A UML model for link aggregation management

This note is a continuation of work begun during the early development of IEEE Standards 802.1Qcp and 802.1Xck. The aim is to help in the review of P802.1AX-Rev¹.

Figure 2—Link Aggregation management (draft)

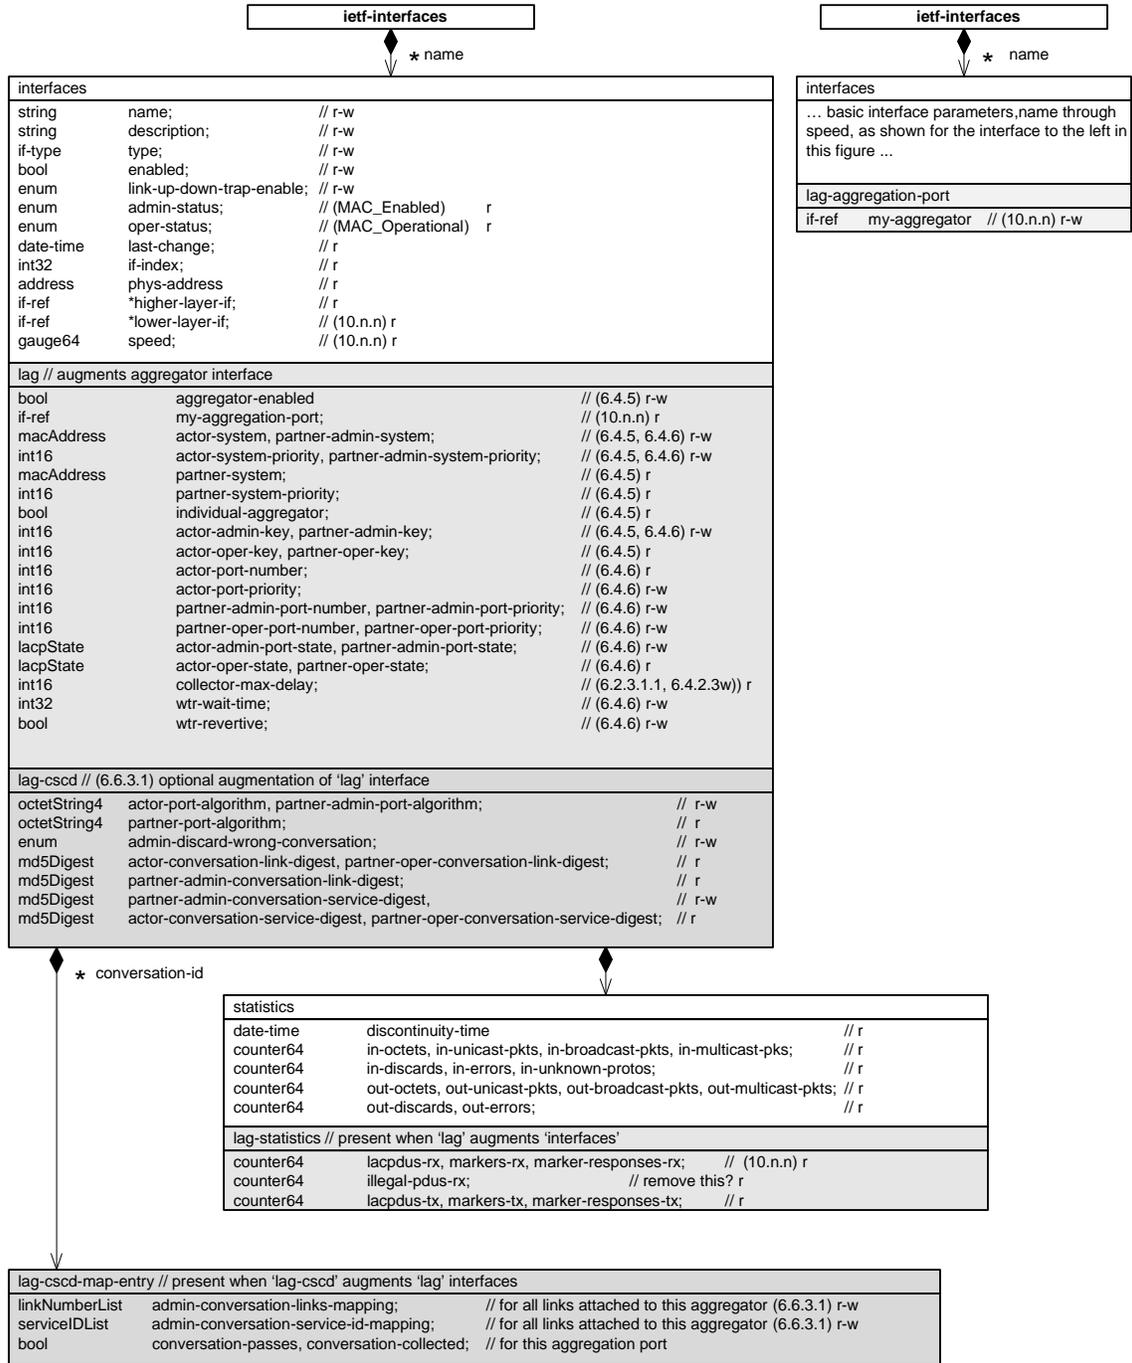
[Figure 2](#) is a UMLish model along these lines. For the present I hope it can speak for itself. UML/YANG attribute names have been aligned with those used in Clauses 6 and 9 (with the exception of seemingly inevitable differences in case stropping/hyphenation/underscore conventions) rather with the Clause 7 variants.

lacpdus-rx: 6.4.8 recordPDU()
 markers-rx: 6.5.4
 marker-responses: 6.5
 lacpdus-tx: 6.4.8 transmitLACPDU()
 markers-tx, markers-responses-tx: 6.5
